# Morbark Ford 6.2 Engine Post Production Modification (PPM-103)

Publish Date:	03/29/2022
Last Revised:	12/7/2022
Created by:	AB/KB
Total Pages:	10
PPM#	103

This document describes the steps required to identify what modifications are required to your specific machine to remedy any instances of engine overheating and include the following:

Figure 1

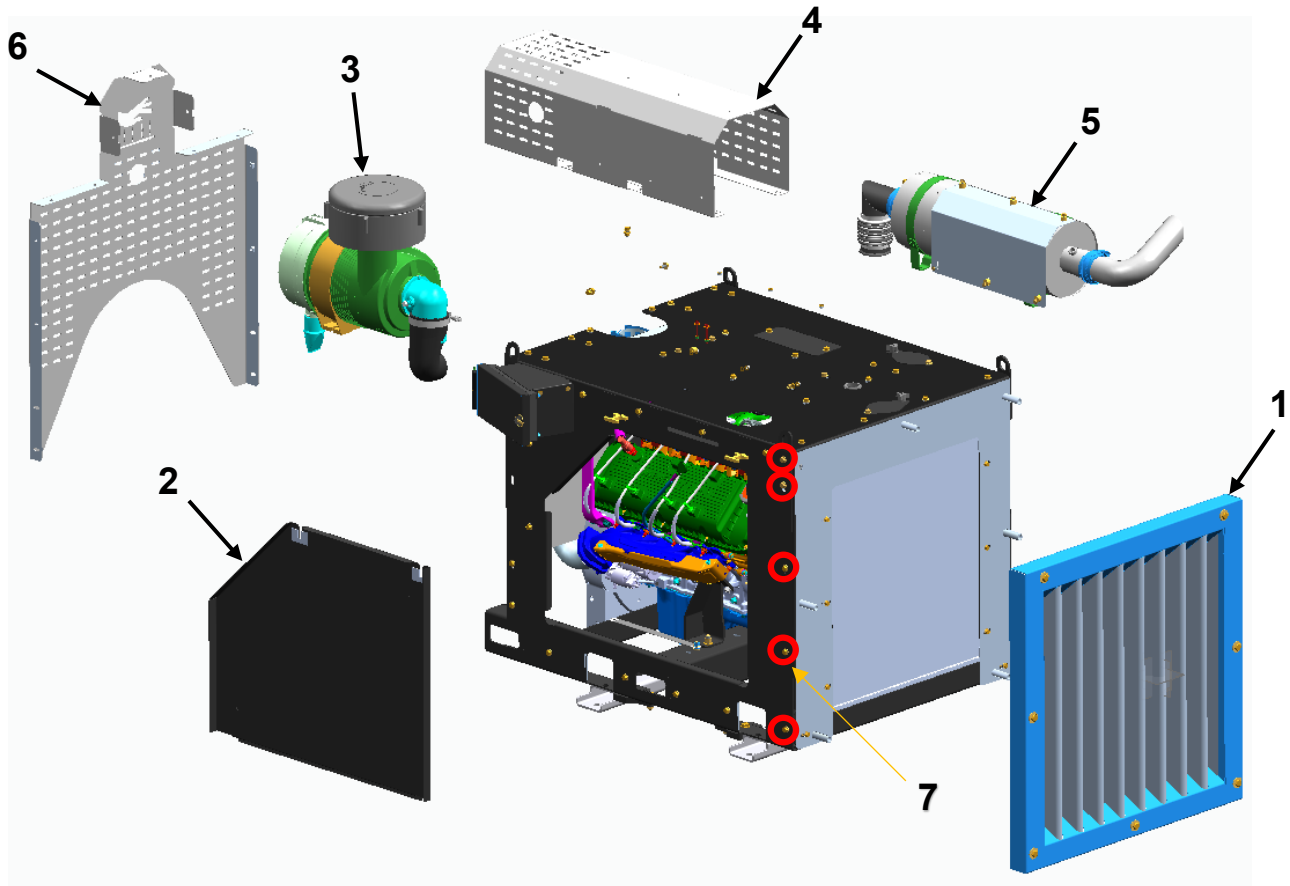
- 1) See Figure 1. Remove the Debris Screen (1), Access Panel (2), Engine Air Intake Assembly (3), Exhaust Heat Shield (4), Muffler Assembly (5), Rear Panel (6) and the hardware used to hold the Radiator Cover Plate sides and Engine Lifting Lugs (highlighted in red circles) on both sides of engine (7) in the order as numbered and set aside.

Figure 2

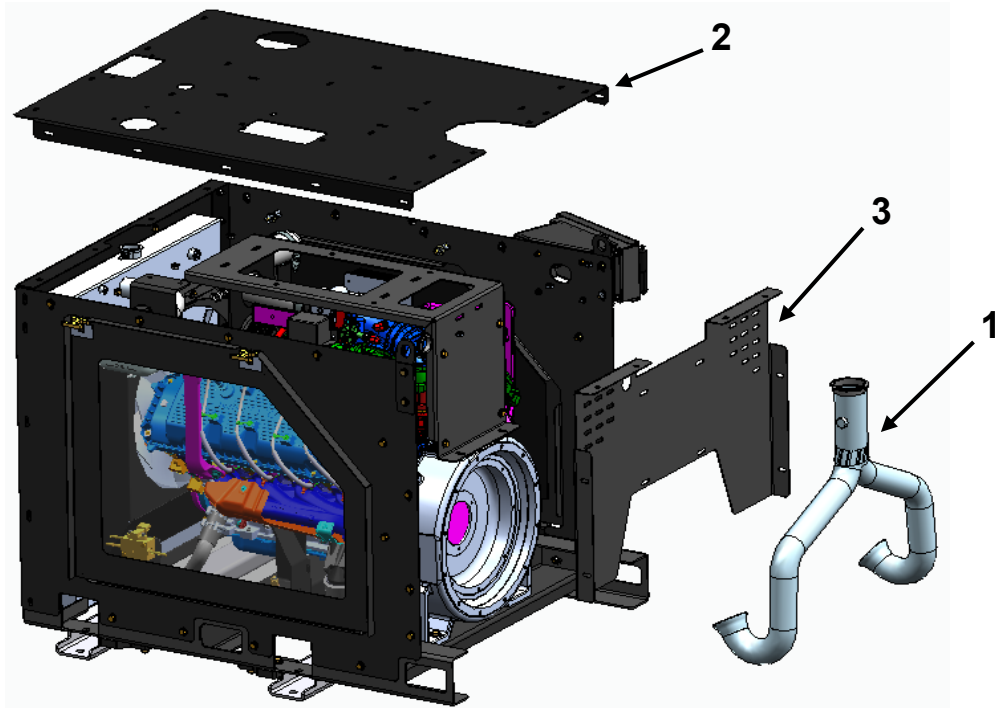
- 2) See Figure 2. Remove Exhaust Pipe (1), Engine Enclosure Top (2) and Chimney Weldment (3) in the order as numbered and set aside.

Figure 3

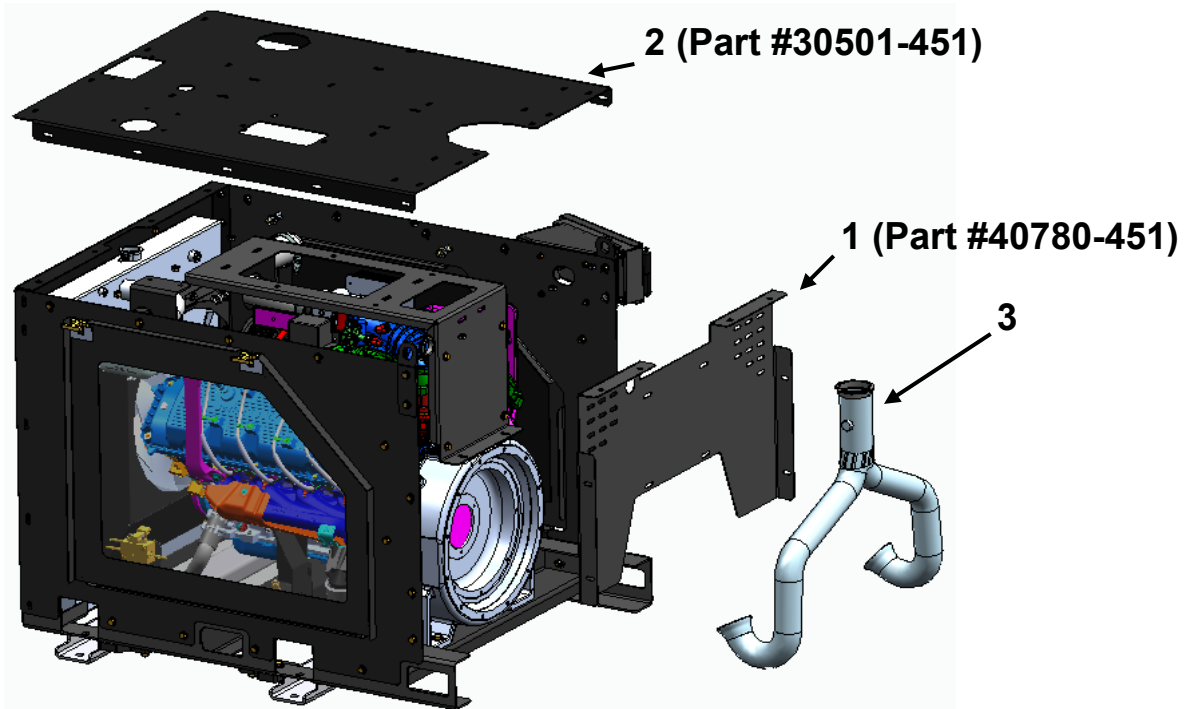
- 3) See Figure 3. Assemble new Chimney Weldment (1), Engine Enclosure Top (2) and existing Exhaust Pipe (3) in the order as numbered using existing hardware.  
**Note: See Figure 4 (next page) for exhaust pipe details before installing.**

**Figure 4**

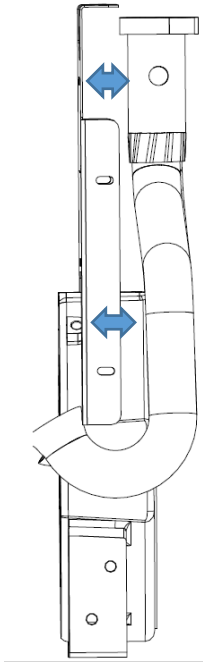
- When changing the fans, adjust the exhaust Y-pipe so it is straight up and down. This component was clamped to the firewall but this allowed too much heat to pass through the firewall.
- Loosen the exhaust manifold joints and pull the pipe back away from the fire wall and re-torque.
- The Catalyst assembly can be adjusted forward and back to allow better fitment of the 90 degree exhaust elbow. Here are some pictures of what it should look like.
- Also remind anyone running a Ford 6.2 liter to only use **5w-30 motor oil**. Using a thicker oil with a higher winter weight (10w, 15w) in the winter may cause timing chain damage.
- Double check that all wiring harnesses are tied back away from any heat sources like the exhaust manifolds.

**NOTE: Do NOT reuse U bolt clamps when re-installing Y-pipe.**

**Make sure pipe is aligned so that there is even clearance between pipe and chimney weldment as shown.**

**Use 3" band clamp. Make sure elbow is fully seated and there are no leaks at slots.**

Figure 7

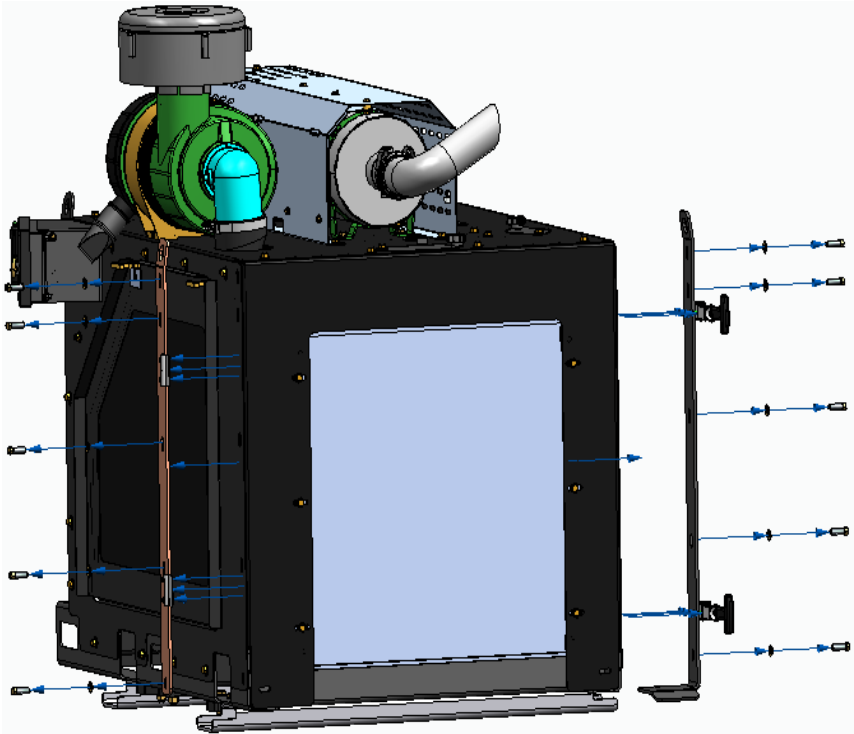
6) See Figure 7. Install new side plates using provided hardware.

Figure 8

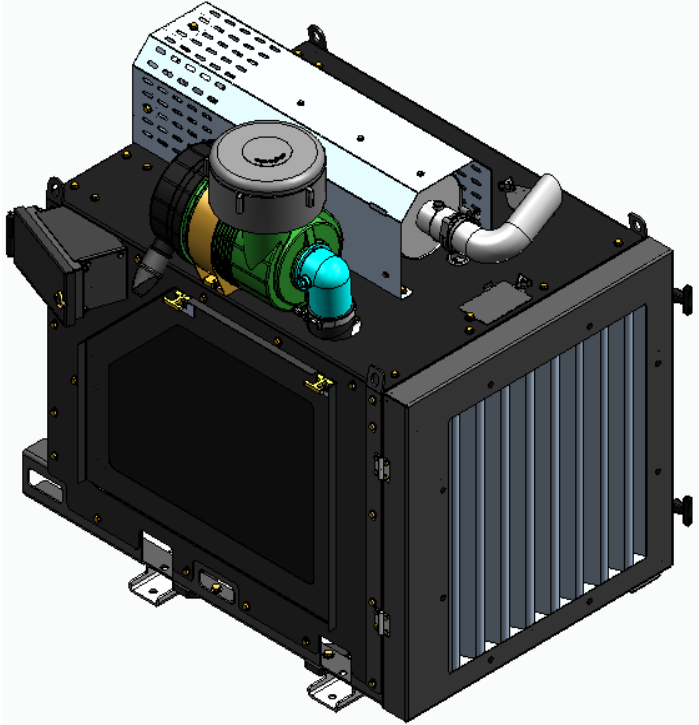
7) See Figure 8. Install new debris screen by sliding it onto hinges and fastening with rubber latches.

Figure 7

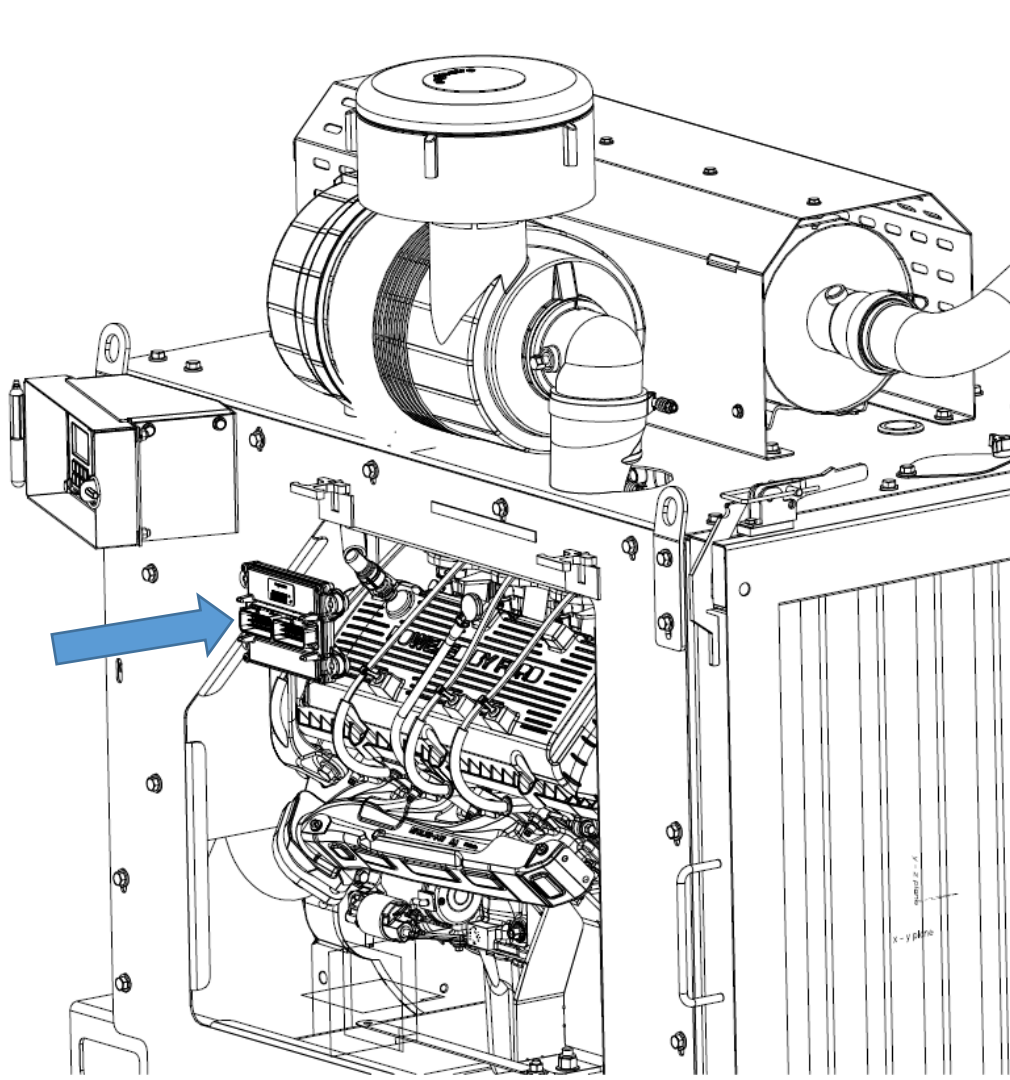
- 1) See Figure 7. Remove screws.
- 2) Disconnect wire harnesses.
- 3) Remove ECM.
- 4) Install new ECM in reverse.

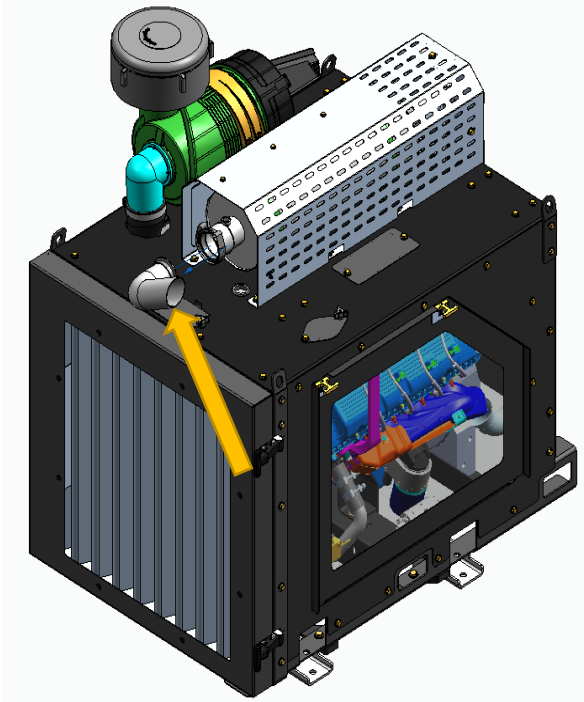
- 2) See figure below. Use a tape measure to see if Catalytic Converter substrate has shifted; the measurement should be no LESS than 11 inches, and NO MORE than 12 inches. If the substrate is outside of these defined limits it must be replaced.
